BOARD OF ADJUSTMENT CASE REPORT

Case Number: **BOA-23370**

ACTION REQUESTED: Special Exception to increase the permitted driveway width in a Residential District (Section 55.090-F.3)

ZONING CLEARANCE PLAN REVIEW

8127 S. Pittsburg Ave.
Tulsa, OK 74137

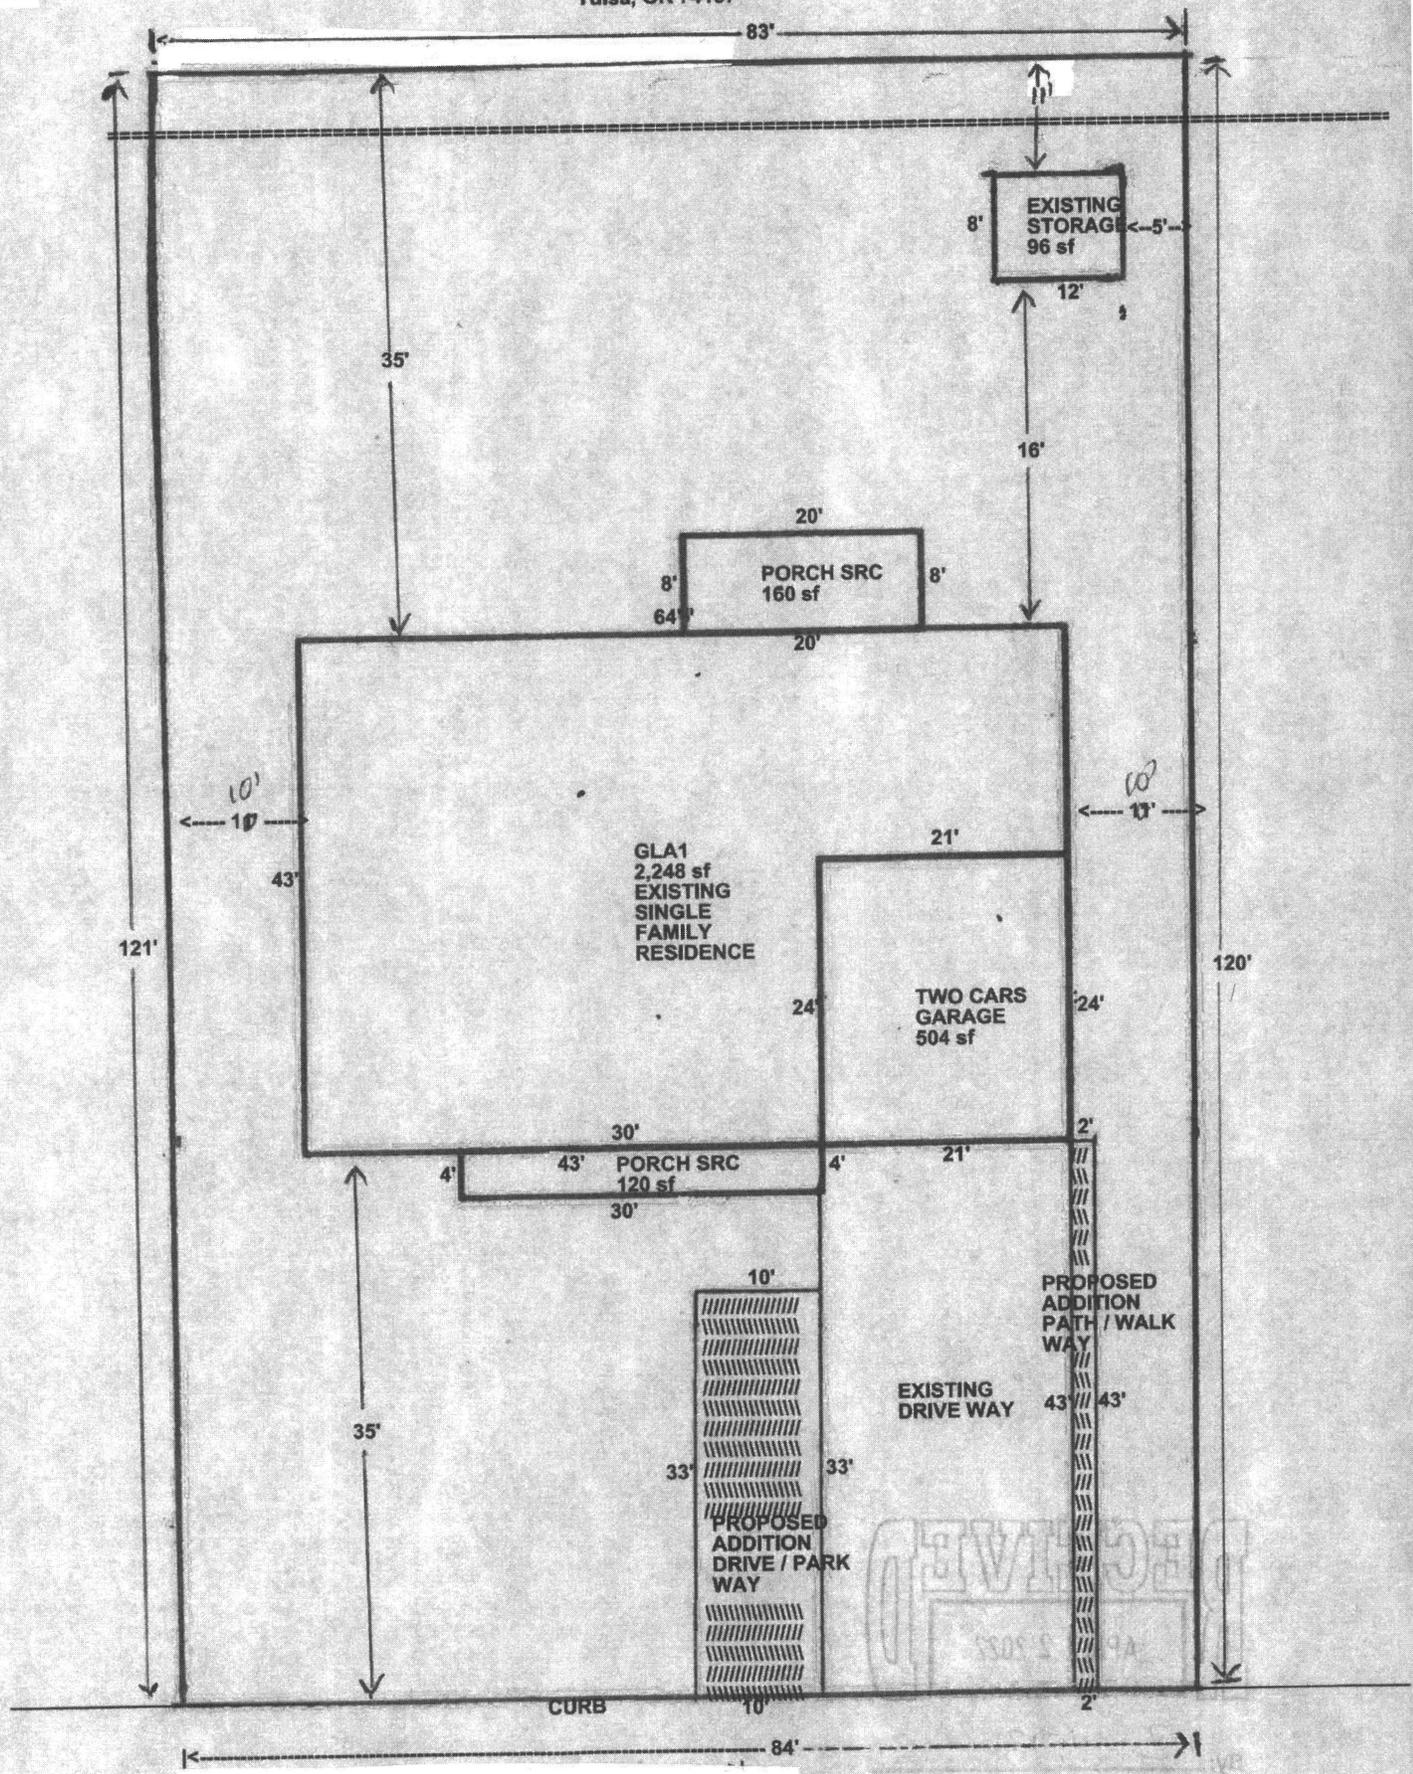
Review Comments: The maximum driveway width permitted on this lot is 30' in the front setback and 27' in the Right-Of-Way. The plans propose a driveway width of 33'. Please revise plans to show compliance or apply to BOA for a special exception to allow a driveway width to exceed the maximum widths. (Note: Please check your existing widths and confirm that the existing driveway is 21'.)
